SERVICE BULLETIN

SB14-2

SUBJECT: Inspection and Replacement of IO240 Starter and Crankshaft Cluster Gear

Figure 1. Removing Starter Drive Assembly (typical)

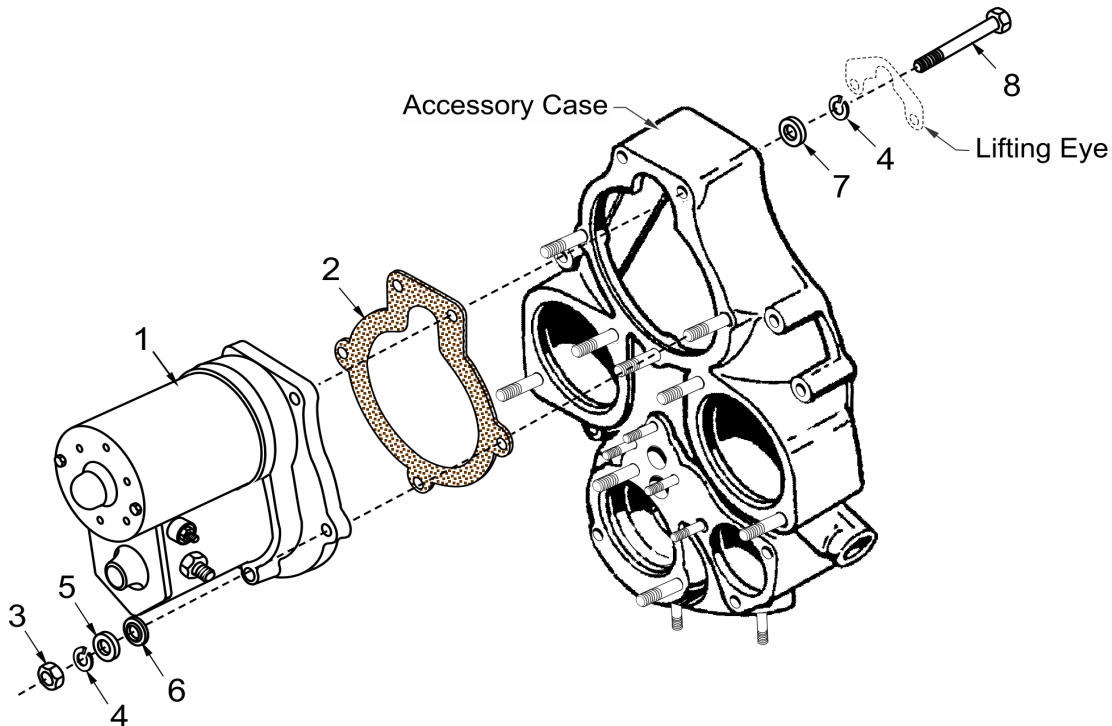
1. Remove attaching washers, spacers, and nuts (Figure 1, items 3, 4, 5 & 6). Discard washers and spacers.
2. Remove bolts (8), lifting eye, and washers (4 & 7), from starter drive assembly housing (1) and accessory case. Replace bolts P/N 538999 with new bolts P/N 630966-4.00 (8) if removing the P/N 634464 starter motor and P/Ns 641500 or 653575 clutch assembly. Retain lifting eye and discard washers.
3. Lightly tap/bump the starter (1) by hand to break the starter gasket (2) adhesion. Carefully remove the starter and clutch, if installed, and discard the starter gasket.

Figure 2. Remove Needle Bearing

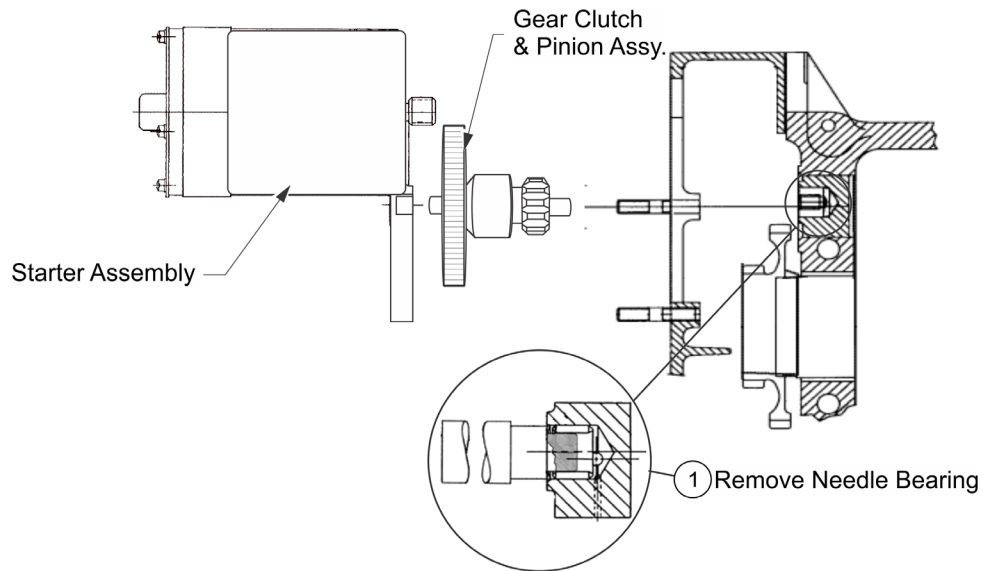
1. Remove existing needle bearing using a 0.50 inch expandable bushing/bearing puller and slide hammer (see Figure 2 and Table 3).

Figure 3. Install Rear Crankcase Plug

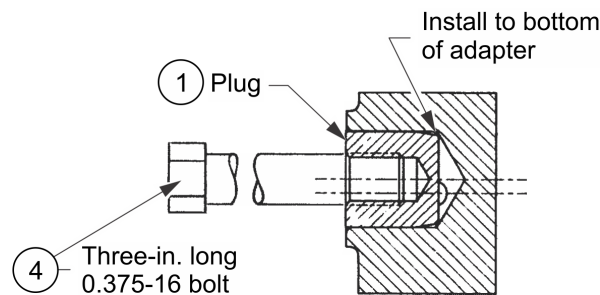
2. Clean bearing bore with Loctite 7070 cleaner (see Table 3, item 2).
3. Screw a three-inch long 0.375-16 bolt (4) into plug (see Figure 3, item 1).
4. Coat exterior circumference of plug (1) with Loctite 222 sealant (3).
5. Tap plug (1) in bearing cavity. Ensure that plug (1) is bottomed in cavity.
6. Remove 0.375-16 bolt (4) from plug (1).

Figure 6. Unacceptable Wear Criteria

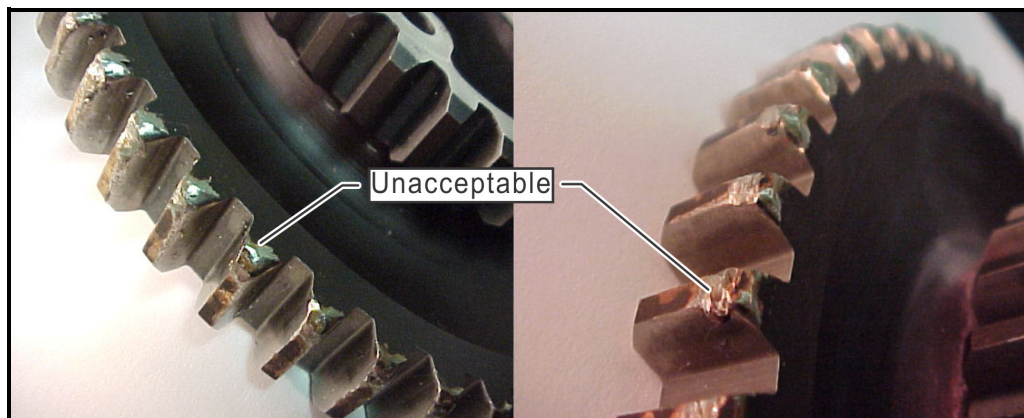
- b. **Unacceptable Wear** - Figure 6 depicts unacceptable or abnormal wear of a crankshaft cluster gear.
- 1) There will be extremely rough areas with damage to the tooth surfaces and the surrounding gear areas.
 - 2) In some circumstances portions of teeth may be broken away from the gear. The most extreme cases may have whole teeth missing.
 - 3) If the damage is considered abnormal **without** complete teeth missing, replace the crankshaft cluster gear in accordance with the instructions contained in the applicable sections of the IO240/IOF240B Maintenance and Overhaul Manuals (M-6/M-22).
 - 4) If the crankshaft cluster gear is missing one or more complete teeth, please contact Continental Motors Customer Service Department directly at 1(800) 326-0089.

Figure 7. Installing New Starter Drive Assembly (typical)

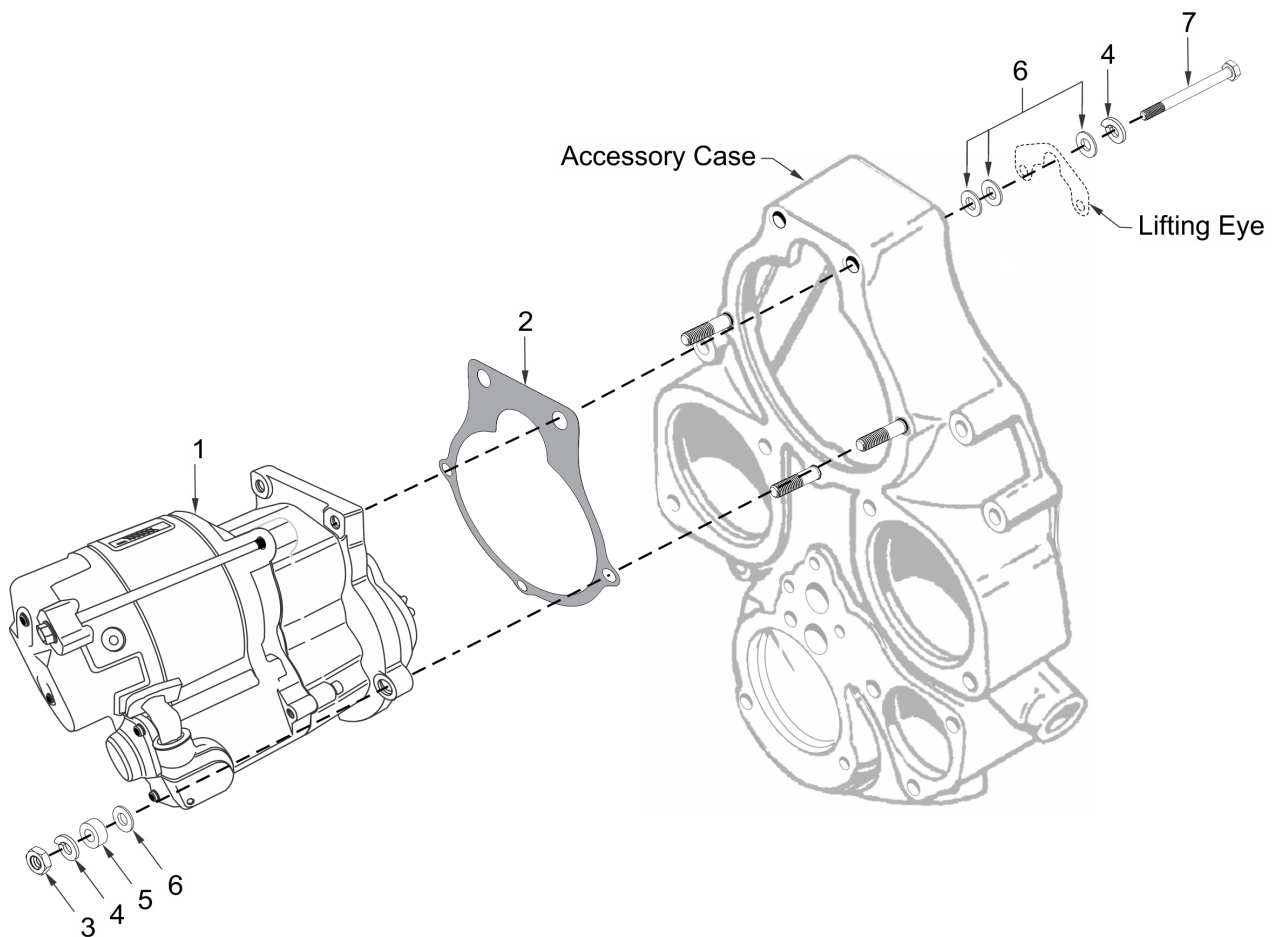
1. Install a new starter gasket (Table 4, item 2) on the accessory case (see Figure 7).
2. Align starter assembly (1) with the accessory case studs and position the starter assembly so that the 3 o'clock stud extends through the housing sufficiently to install fasteners.

3. Place the washer (6), spacer (5), lock washer (4) and start the nut (3) onto the stud threads.
4. Seat the starter assembly (1) against the gasket (2) and install the remaining fasteners on the remaining case studs in a clockwise order. Do not tighten hardware at this time.

5. Secure the upper portion of the starter assembly (1) to the accessory case by installing two bolts (7), lock washers (4), lifting eye, and flat washers (6).

6. Torque nuts (3) and bolts (7) to 180-220 inch pounds of torque.
7. If a new starter lead is required, replace and install the electrical connection on the starter assembly in accordance with the aircraft manufacturer's instructions.

8. Torque electrical connection on the starter assembly to 50 inch pounds.
